# **Z-axis Backlash Modification**

### Reason for the design change

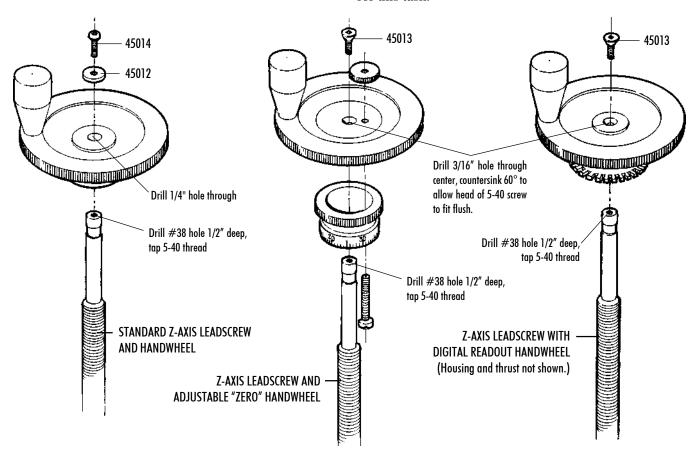
Since its original design, the Sherline mill column has been produced in the same manner. The weight of the motor/speed control unit is ultimately transferred to the handwheel set screw. In almost 30 years, this has caused almost no problems; however, in some cases, the set screw can "settle" on the leadscrew, allowing backlash to increase. This is aggravated by pounding on the drawbolt in the spindle to release a #1 Morse taper on a chuck or tool. To reduce the possibility of this happening, Sherline introduced a production change. As of January 2001, new Sherline mills include a screw that goes through the center of the Z-axis handwheel and into the end of the leadscrew to help distribute this load. It is still a good idea to support the headstock when tapping on a drawbolt so the shock isn't transferred to the supporting parts and fasteners.

Because of the many leadscrew/handwheel combinations, "upgrade kits" to convert older mills are not offered, but it is a simple process to do it yourself. A mill owner can simply center drill the handwheel and leadscrew and install a support screw. We use a 5-40 x 3/8" screw for this purpose. On standard handwheels, this is a button head cap screw P/N 45014. A #6 flat washer (P/N 45012) goes under the head of the screw. On adjustable "zero" handwheels, the screw must be countersunk flush with the surface so that it does not interfere with the locking collar. For this purpose, we use a 5-40 flat head socket head screw P/N 45013. The screws and washer can be

To adjust tension on the screw, first remove all Z-axis backlash in the conventional manner by lifting the motor/speed control unit by hand while tightening the handwheel set screw on a "fresh" quadrant of the leadscrew to avoid picking up any previous indentations. Once adjusted, tighten the new center screw only until it is "finger tight". Use a very small amount of Loc-tite® on the end of the screw to keep it in place. (Do not coat the threads or the screw may become impossible to remove.) Overtightening the screw will cause the handwheel to become hard to turn. The purpose of the screw is not to adjust backlash, but rather to keep it from increasing once it is properly adjusted. Do not try to use the screw to pull out additional backlash. The small 5-40 threads are not strong enough for this task.
